**Cardinia Planning Scheme Amendment C238card
Glismann Road, Beaconsfield**

Panel Report

4 January 2022

Figure 6: Section of Development Plan (masterplan) showing road connection to 11 Mahon Avenue

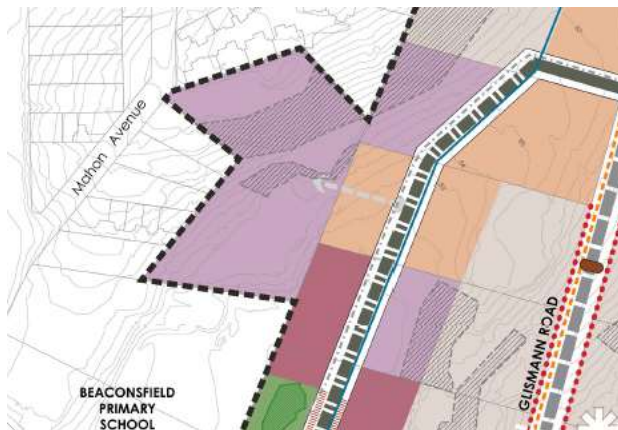
The Panel considers that, at minimum, development of 11 Mahon Avenue should include a pedestrian link to the Glismann Road area. This would provide access from Mahon Avenue to the new public open space area in the Glismann Road area near Beaconsfield Primary School, and pedestrian connectivity between the areas.

An implication of the removal of 11 Mahon Avenue from the Amendment is the treatment of the *"Road connection"* in the Development Plan (masterplan) exhibited in DPO19, shown in Figure 6.

Remove 11 Mahon Avenue from the rezoning and Development Contributions Plan Overlay, but leave it in the Development Plan Overlay, and

- allow a permit to be issued for the development of 11 Mahon Avenue subject to a pedestrian link**
- include a notation "*Pedestrian connection required*" to 11 Mahon Avenue in the Development Plan (masterplan) shown on the Development Plan Overlay schedule.**

Figure 8: Optimised Transport Network proposed by Mr Maina

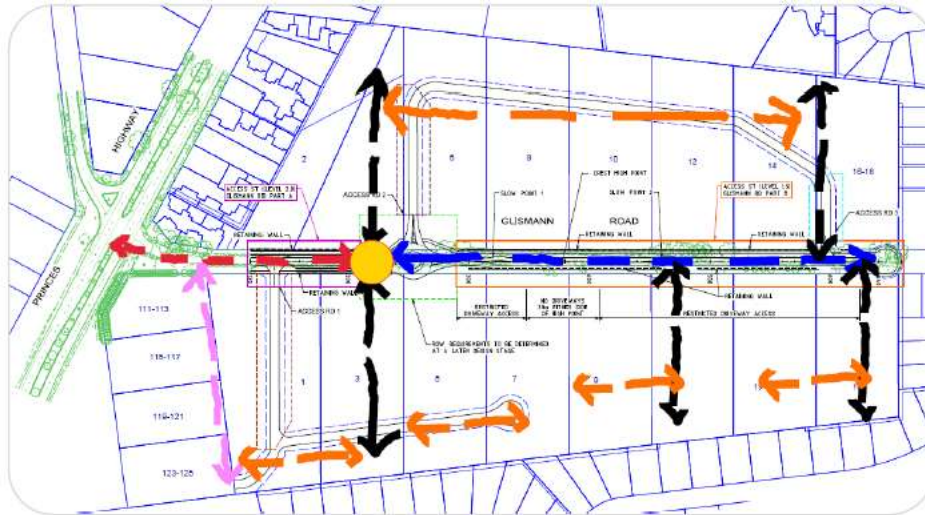
Mr Maina of Impact Traffic Engineering gave evidence on behalf of the Glismann Rd residents. He focused on the lack of permeability and resilience in the proposed road network, particularly east of Glismann Road. He submitted an alternative design (see proposed ‘optimised transport network’ Figure 8), with the roundabout on Glismann Road relocated to the west by about 30 to 50 metres, and the following changes east of Glismann Road:

- an access lane a direct connection to Glismann Road to the rear of the lots that have a frontage to Princes Highway
- short east - west local road cul-de-sacs to provide access to lots that are landlocked.

Figure 10: Detail of Traffic Impact Assessment design of roundabout

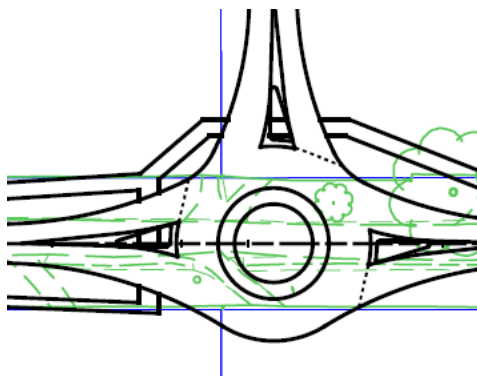
The Panel notes that the proposed footpath to the west of the roundabout in Glismann Road in the TIA encroaches on the property referred to in Submission 4.
